The Commission has issued the enclosed Amendment.NN. 46 to Facility Operating License No. DPR-65 for Millstone Nuclear Power Station, Unit No. 2. The amendment consists of changes to the Technical Specifications in response to your application dated October 24, 1977, as supplemented by letter dated March 21, 1978.

The amendment modified the existing Technical Specifications by changing the acceptable Resistance Temperature Detector (RTD) response time in the Reactor Protection System from less than or equal to five seconds to less than or equal to ten seconds. This change also affects the computation of the Thermal Margin/Low Pressure trip setpoint.

AMENDMENT TO FACILITY OPERATING LICENSE

SAFETY EVALUATION BY THE OFFICE OF NUCLEAR REACTOR REGULATION
SUPPORTING AMENDMENT NO. 46 TO FACILITY OPERATING LICENSE NO. DPR-65
NORTHEAST NUCLEAR ENERGY COMPANY, ET AL
MILLSTONE NUCLEAR POWER STATION, UNIT NO. 2
DOCKET NO. 50-336

FIGURE 2.2-4
 Thermal Margin/Low Pressure Trip Setpoint
 (Part 2 Fraction of RATED THERMAL POWER Versus QR₁)

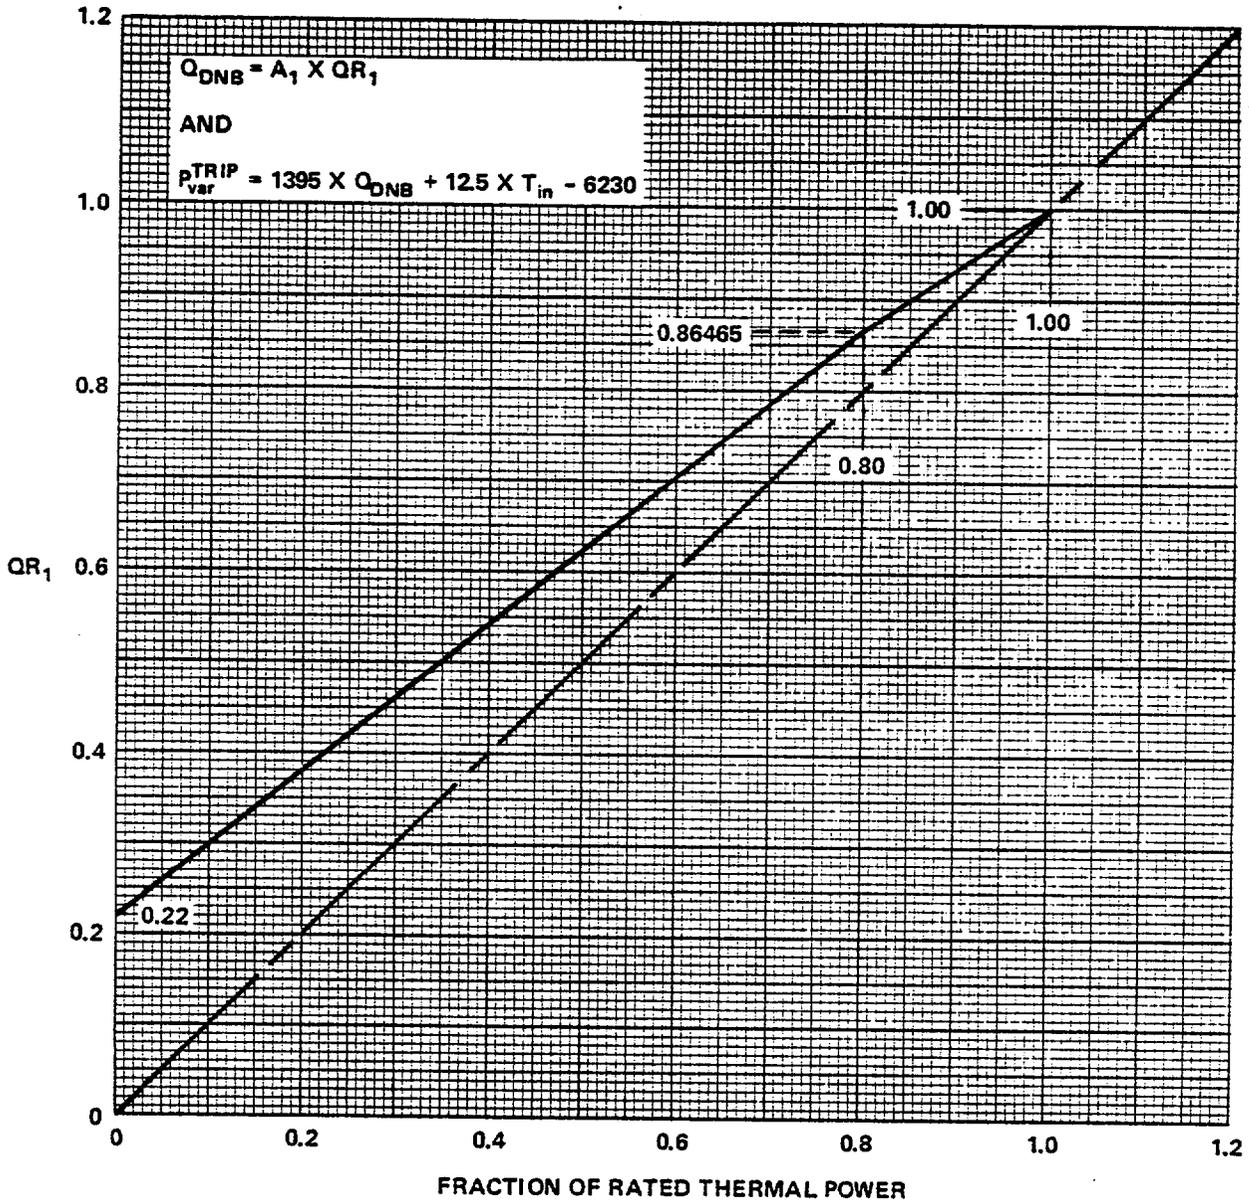
Increasing the RTD response time from less than or equal to five seconds to less than or equal to ten seconds has two effects on the TM/LP trip setpoint. First, the shape of the TS Figure 2.2-4 would be modified for low power level operation. (The QR-1 function of Figure 2.2-4 is a function of the TM/LP trip setpoint to account for increased radial peaking due to rod insertion assuming the rods are inserted anywhere up to the power dependent insertion limit.) However, since NNECO proposed Figure 2.2-4 based on a ten second RTD response time for the Cycle 2 reload, and we issued the proposed figure in Amendment No. 38 dated April 19, 1978, no change is required in regard to the shape of this LSSS figure.
